Josephs/Carr Residence

Permit Revision #1

HISTORIC PRESERVATION COMMISSION STAFF REPORT

Proposal: Revisions to Approved HAWP

Elevations

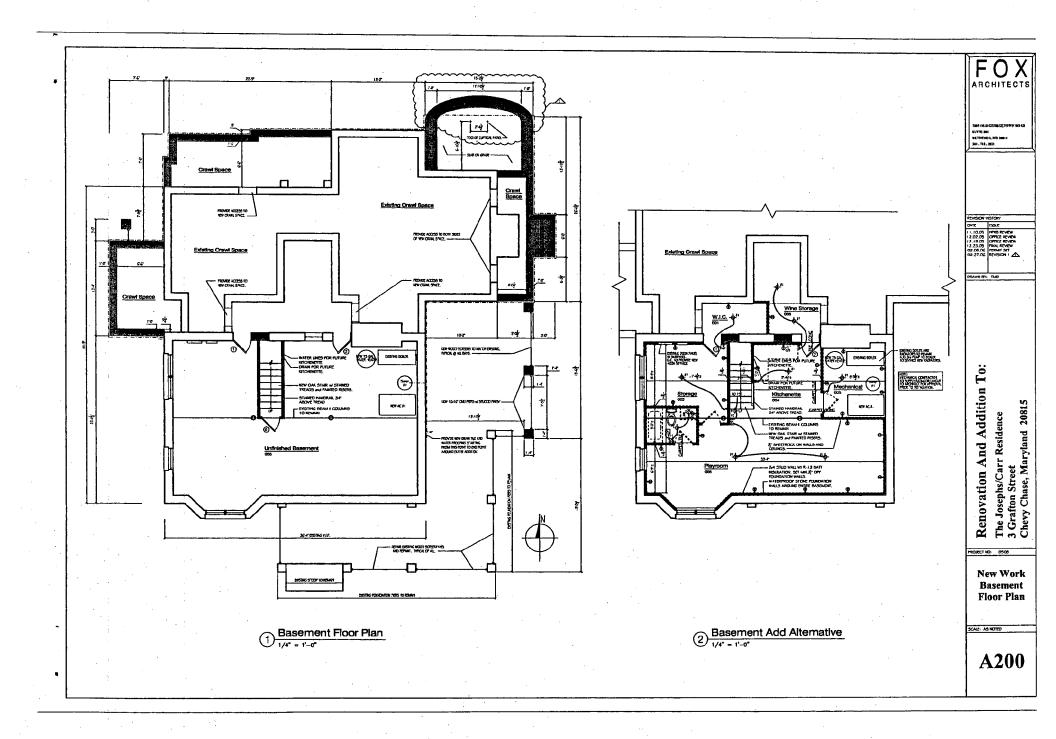
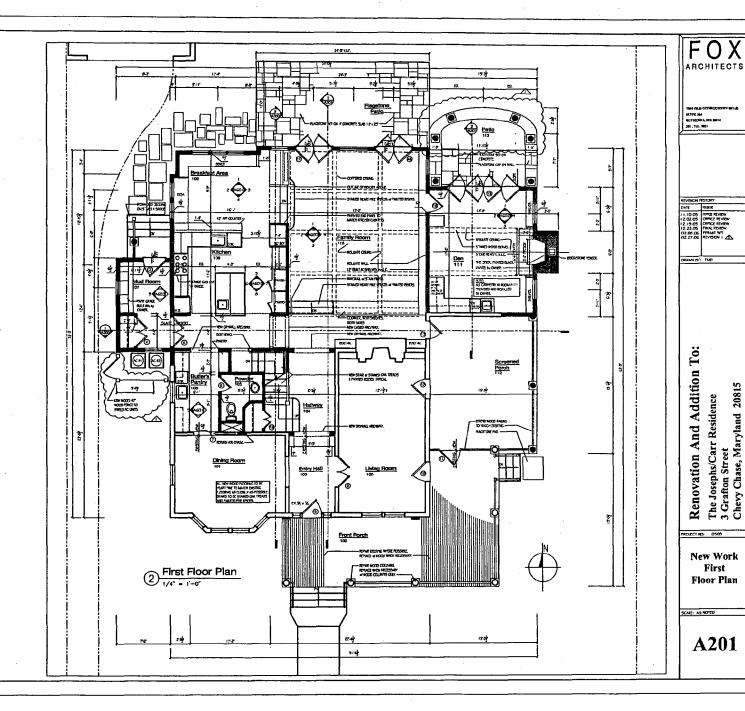
Front Elevation

1. Installation of a wood, 42" high AC enclosure (7' long x 4' deep) in front of the new mud from addition.

Right Side Elevation

2. A reduction in the size of the window openings in lower level of new addition, which flank the new chimney.

Left Side Elevation

- 3. Adjustment in the window placement on the second floor of the addition.
- 4. Adjustment in the window size on the first floor of the addition.
- 5. Alteration to the roof form of the one-story mudroom addition. The approved plans had a smaller gambrel roof with a gable roof over entry. The proposed has the addition and the entry under a larger gambrel roof. The footprint of the mudroom has not changed.
- 6. Installation of a flush mount, skylight above new (already approved), eyebrow window (located on a Dutch gambrel roof on a side elevation 85' back from street).

Rear Elevation

- 7. Installation of sidelights flanking the French door on the first floor of the addition.
- 8. Reconfiguration of windows and door placement on the first and second floors of the two-story addition.

The proposed revisions to the approved plan are all to be located on the new additions and do not affect the historic resource. The only change in the approved footprint is a change in the rear open porch from a square porch to a ½ round design. The other proposed changes include alterations to the locations and sizes of windows on the addition and a change in the roof design for the mudroom addition. These proposed changes are sympathetic to the historic character of the original massing.

Staff recommends that the Commission approve this revised HAWP application.
